UNITED STATES PATENT AND TRADEMARK OFFICE

10/618,689

Robert L. Doubler

Office Action Summary

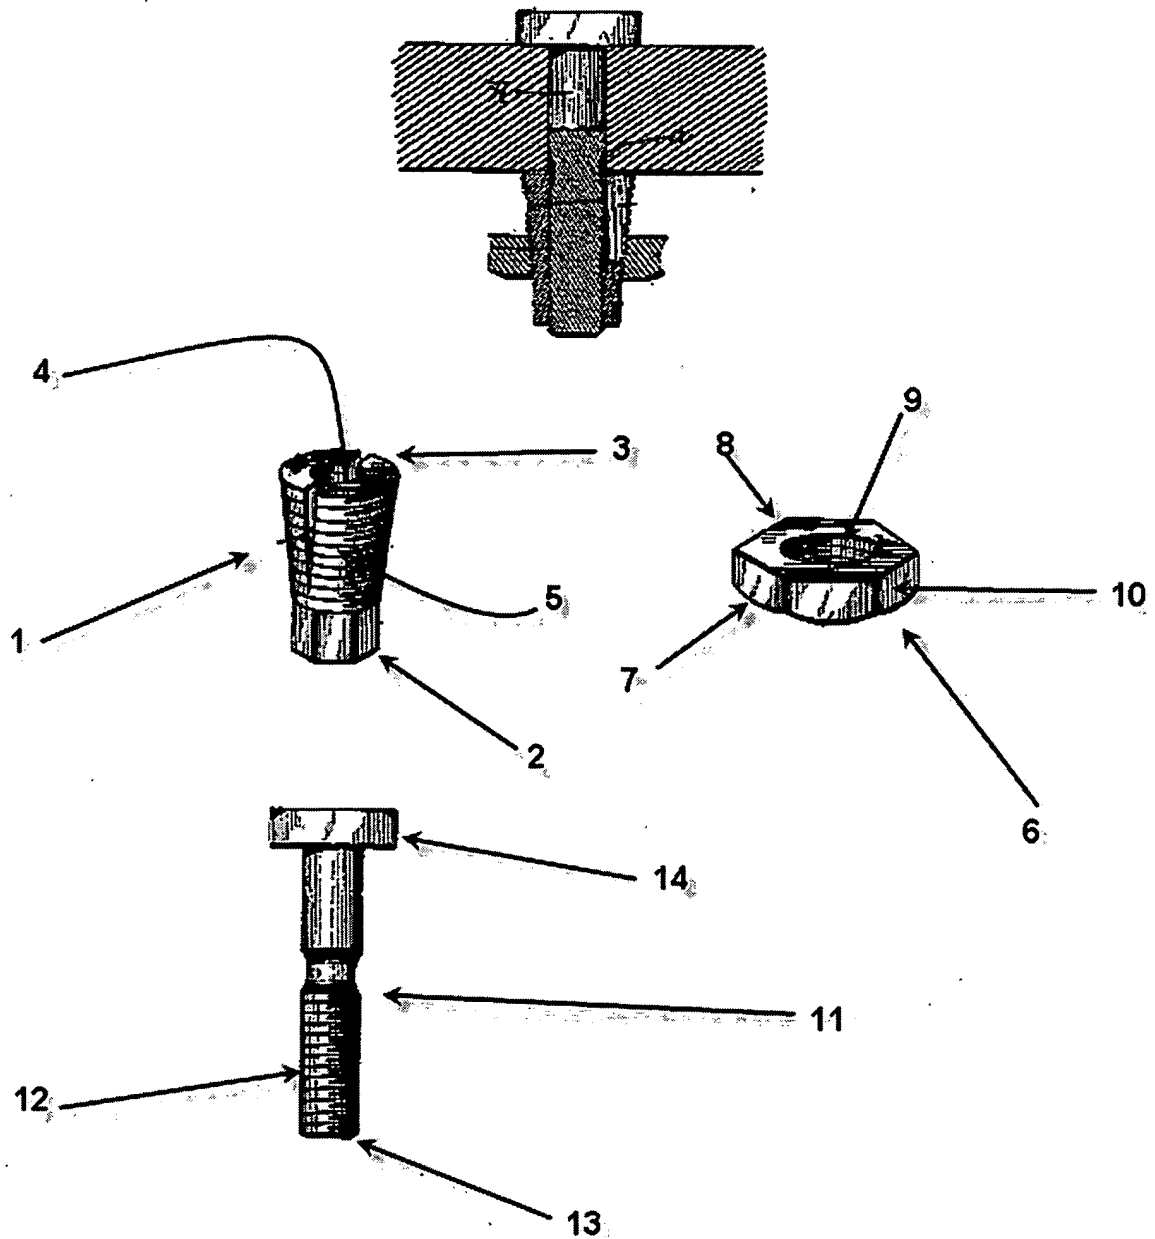
[6] Claims 1-5, 10, and 17 are rejected under 35 U.S.C. 102(b) as clearly anticipated by Archer, US-590,294, because the invention was patented or described in a printed publication in this or a foreign country, or in public use or on sale in this country more than one (1) year prior to the application for patent in the United States.

As for Claim 1, Archer discloses a linear fastener system (see figures below) comprising:
a collet member (1) having a base end (2), a top end (3), an inner engaging surface (4),
and an outer ribbed surface (5) positioned about a central axis;

a compression ring member (6) having a base end (7), a front end (8), an inner ribbed surface (9), and an outer surface (10) positioned about a central axis;

said inner ribbed surface (9) of said compression ring member (6) being constructed and arranged for coaxial alignment and overlapping engagement with respect to said outer ribbed surface (5) of said collet member (1), said compression ring member (6) linearly traversable with respect to said outer ribbed surface (5) of said collet member (1) between a first release position and a second engaged position, wherein said engaged position results in said ribbed surfaces (9) compressing said collet member (1) and tensilely loading said compression ring (6) member to engage a shank member (11) having an outer gripping surface (12), and wherein said release position results in expansion of said collet member (1) thereby releasing said outer gripping surface (12) of said shank member (11).

Re: Claim 2, including a shank member (11) having an outer gripping surface (12), a first end (14), and a second end (13).

Re: Claim 3, wherein said ribbed outer surface (5) of said collet member (1) includes at least one outwardly and circumferentially extending rib (5), each said rib including a first ramp surface to facilitate coaxially aligned linear overlapping movement of said compression ring (6) in relation to said collet member (1) for engagement thereof, and a second ramp surface to facilitate linear removal of said compression ring (6) from said collet member (1).

Re: Claim 4, wherein said inner engaging surface (4) of said collet member (1) is constructed and arranged with a conjugate shape in relation to said outer gripping surface (12) of said shank member (11).

Re: Claim 5, wherein said inner engaging surface (4) of said collet member (1) constructed and arranged with internal threads (4).

Re: Claim 10, wherein said first end (14) of said shank member (11) includes a tensioning means (14), said tensioning means (14) being constructed and arranged to allow said shank member (11) to be tensilely loaded prior to linear traversal of said compression ring member (6) into said engagement position with respect to said collet member (1).

As for Claim 17, wherein said outer ribbed surface (5) of said collet member (1) and said inner ribbed surface (9) of said compression ring member (6) are constructed and arranged to maintain an axially aligned interfitting relationship in said release position (with compression member (6) near the bottom of said collet member, (1).

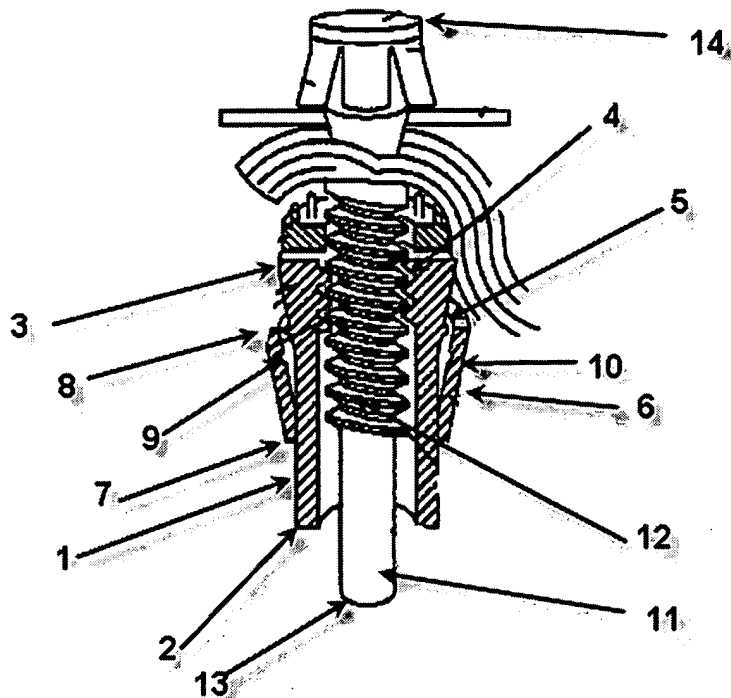
[7] Claims 1-5, 10, 13, and 17 are rejected under 35 U.S.C. 102(b) as clearly anticipated by Freedland et al., US-6,162,234, because the invention was patented or described in a printed publication in this or a foreign country, or in public use or on sale in this country more than one (1) year prior to the application for patent in the United States.

As for Claim 1, Freedland et al. discloses a linear fastener system (see figure below) comprising:

a collet member (1) having a base end (2), a top end (3), an inner engaging surface (4), and an outer ribbed surface (5) positioned about a central axis;

a compression ring member (6) having a base end (7), a front end (8), an inner ribbed surface (9), and an outer surface (10) positioned about a central axis;

said inner ribbed surface (9) of said compression ring member (6) being constructed and arranged for coaxial alignment and overlapping engagement with respect to said outer ribbed surface (5) of said collet member (1), said compression ring member (6) linearly traversable with respect to said outer ribbed surface (5) of said collet member (1) between a first release position and a second engaged position, wherein said engaged position results in said ribbed surfaces (9) compressing said collet member (1) and tensilely loading said compression ring (6) member to engage a shank member (11) having an outer gripping surface (12), and wherein said release position results in expansion of said collet member (1) thereby releasing said outer gripping surface (12) of said shank member (11).

Re: Claim 2, including a shank member (11) having an outer gripping surface (12), a first end (14), and a second end (13).

Re: Claim 3, wherein said ribbed outer surface (5) of said collet member (1) includes at least one outwardly and circumferentially extending rib (5), each said rib including a first ramp surface to facilitate coaxially aligned linear overlapping movement of said compression ring (6) in relation to said collet member (1) for engagement thereof, and a second ramp surface to facilitate linear removal of said compression ring (6) from said collet member (1).

Re: Claim 4, wherein said inner engaging surface (4) of said collet member (1) is constructed and arranged with a conjugate shape in relation to said outer gripping surface (12) of said shank member (11).

Re: Claim 5, wherein said inner engaging surface (4) of said collet member (1) constructed and arranged with internal threads (4).

Re: Claim 10, wherein said first end (14) of said shank member (11) includes a tensioning means (111E1 in Fig. 43), said tensioning means (111E1 in Fig. 43) being constructed and arranged to allow said shank member (11) to be tensilely loaded (via 6) prior to linear traversal of said compression ring member (6) into said engagement position with respect to said collet member (1).

Re: Claim 13, wherein said shank member tensioning means (111E1 in Fig. 43) includes at least one internal bore (111E1 in Fig. 43) extending inwardly from said first end of said shank member (14 in view of 111E1 in Fig. 43) along the longitudinal centerline of said shank member (11), wherein said at least one internal bore (111E1 in Fig. 43) is constructed and arranged for gripping and placing a tensile load (via 6) on said shank member (11) prior to linear traversal of said compression ring member (6) into said engagement position with respect to said collet member (1).

Re: Claim 17, wherein said outer ribbed surface (5) of said collet member (1) and said inner ribbed surface (9) of said compression ring member (6) are constructed and arranged to maintain an axially aligned interfitting relationship in said release position (with compression member (6) near the bottom of said collet member, (1).

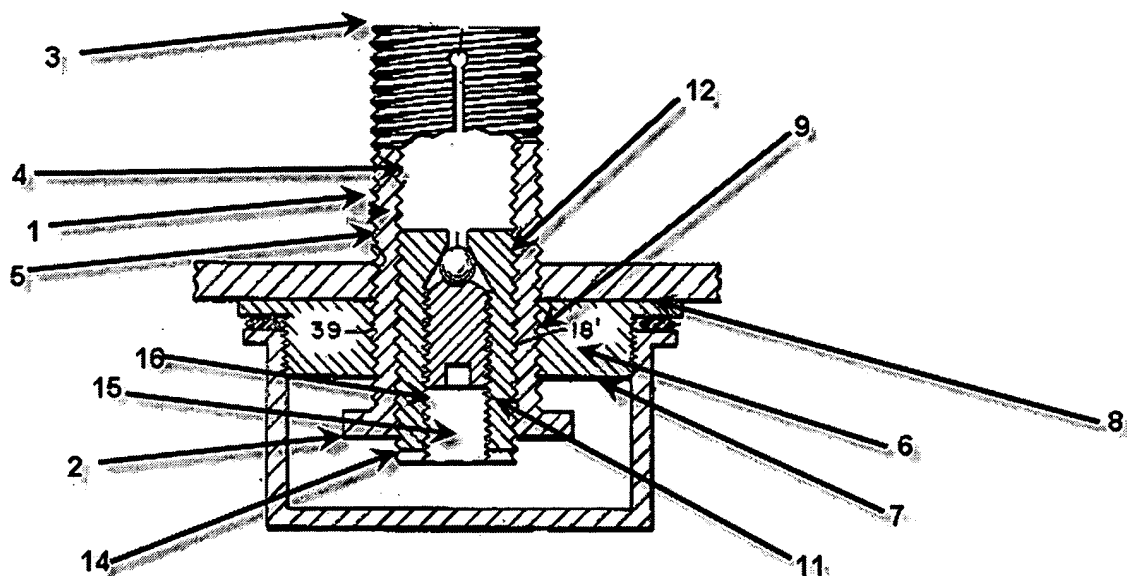
[8] Claims 1-5, 10, 13-14 and 17 are rejected under 35 U.S.C. 102(b) as clearly anticipated by Weller, US-3,618,135, because the invention was patented or described in a printed publication in this or a foreign country, or in public use or on sale in this country more than one (1) year prior to the application for patent in the United States.

As for Claim 1, Weller discloses a linear fastener system (see figure below) comprising:
a collet member (1) having a base end (2), a top end (3), an inner engaging surface (4),
and an outer ribbed surface (5) positioned about a central axis;

a compression ring member (6) having a base end (7), a front end (8), an inner ribbed surface (9), and an outer surface (10) positioned about a central axis;

said inner ribbed surface (9) of said compression ring member (6) being constructed and arranged for coaxial alignment and overlapping engagement with respect to said outer ribbed surface (5) of said collet member (1), said compression ring member (6) linearly traversable with respect to said outer ribbed surface (5) of said collet member (1) between a first release position and a second engaged position, wherein said engaged position results in said ribbed surfaces (9) compressing said collet member (1) and tensilely loading said compression ring (6) member to engage a shank member (11) having an outer gripping surface (12), and wherein said release position results in expansion of said collet member (1) thereby releasing said outer gripping surface (12) of said shank member (11).

Re: Claim 2, including a shank member (11) having an outer gripping surface (12), a first end (14), and a second end (13).

Re: Claim 3, wherein said ribbed outer surface (5) of said collet member (1) includes at least one outwardly and circumferentially extending rib (5), each said rib including a first ramp surface to facilitate coaxially aligned linear overlapping movement of said compression ring (6) in relation to said collet member (1) for engagement thereof, and a second ramp surface to facilitate linear removal of said compression ring (6) from said collet member (1).

Re: Claim 4, wherein said inner engaging surface (4) of said collet member (1) is constructed and arranged with a conjugate shape in relation to said outer gripping surface (12) of said shank member (11).

Re: Claim 5, wherein said inner engaging surface (4) of said collet member (1) constructed and arranged with internal threads (4).

Re: Claim 10, wherein said first end (14) of said shank member (11) includes a tensioning means (15-16), said tensioning means (15-16) being constructed and arranged to allow said shank member (11) to be tensilely loaded prior to linear traversal of said compression ring member (6) into said engagement position with respect to said collet member (1).

Re: Claim 13, wherein said shank member tensioning means (15-16) includes at least one internal bore (15) extending inwardly from said first end of said shank member (11) along the longitudinal centerline of said shank member (11), wherein said at least one internal bore (15) is constructed and arranged for gripping and placing a tensile load on said shank member (11) prior to linear traversal of said compression ring member (6) into said engagement position with respect to said collet member (1).

Re: Claim 14, wherein said internal bore (15) includes internal threads (16).

Re: Claim 17, wherein said outer ribbed surface (5) of said collet member (1) and said inner ribbed surface (9) of said compression ring member (6) are constructed and arranged to maintain an axially aligned interfitting relationship in said release position (with compression member (6) near the bottom of said collet member, (1).
